In the Matter of)	
)	Docket No. 50-0219-LR
AMERGEN ENERGY COMPANY, LLC)	
)	ASLB No. 06-844-01-LR
(License Renewal for the Oyster Creek)	
Nuclear Generating Station))	May 5, 2006

**CITIZENS' BRIEF IN OPPOSITION TO AMERGEN'S MOTION TO DISMISS AND
TO SUSPEND MANDATORY DISCLOSURES**

Subject: Oyster Creek Dry Well Corrosion
Comments regarding "Audit Q&A (Question Numbers AMP -141,
210, 356) dated 4/5/06, Ref. ML060960563

NRC Information Request Form

Figure 1

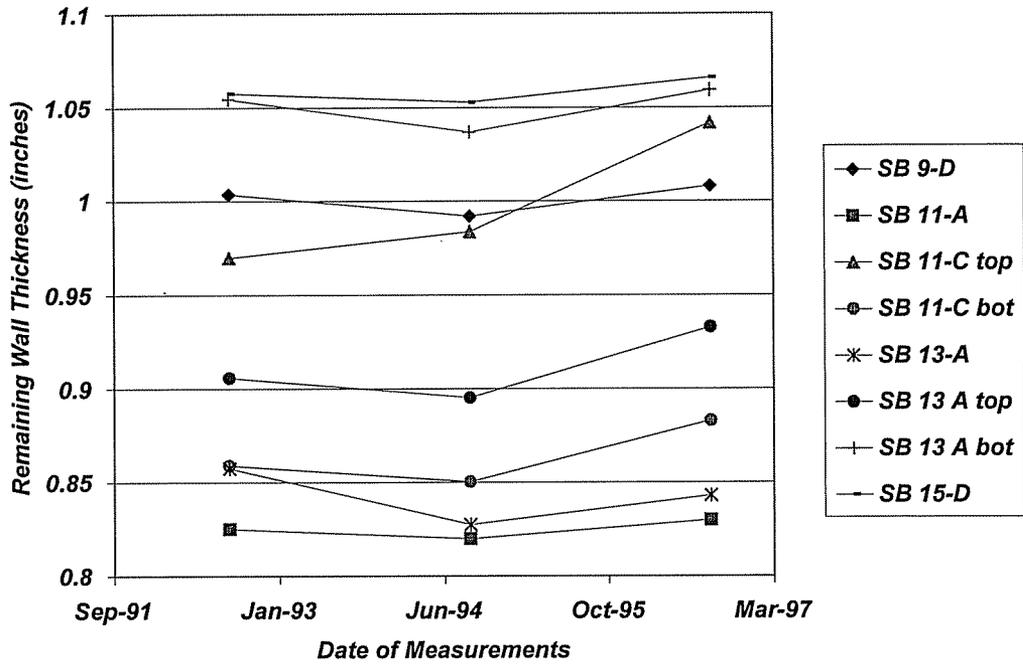
First, it is noted that with unflinching regularity (even in the cases not shown in Figure 1 below) the AMGT for each grid decreases from 1992 to 1994, but then *increases* in 1996. This is of course physically impossible; metal simply does not spontaneously get thicker. Furthermore, statistically, UT measurements in general are accurate within a standard deviation of 2% of wall thickness (modern methodologies can do better). Assuming for a moment that all 49 measurements within a grid measured the same wall thickness, then the average would have had a standard deviation of 2/7 % or about 0.3% of wall thickness which corresponds to +/- 2.5 mils or 95% confidence limits of +/- 5 mils. Since however, not all measurements within the grid were of the same wall thickness, the variability of individual measurements within the grid must have been larger than the standard deviation derived from instrument capability. Exelon assures us that "the tolerance is or the order of +/- 10 mils. As it turns out, the variability of the AMGT for the three measurements for a particular grid expressed as a standard deviation in almost all cases exceeds the +/- 10 mils by a large margin. **I interpret this as a systematic error in the UT methodology employed.**

Moreover, the repeated trends over time observed in Fig. 1 below from high to low to high values underlines the unreliability to these UT measurements. Clearly, the methodology chosen by Exelon to monitor corrosion in the sandbed area is difficult in practice for a number of reasons. **However, these difficulties do not excuse the improper extrapolation of sporadic data obtained over a four-year period to another 10 years and the untenable and irresponsible conclusion that corrosion in the sandbed area therefore is under control.**
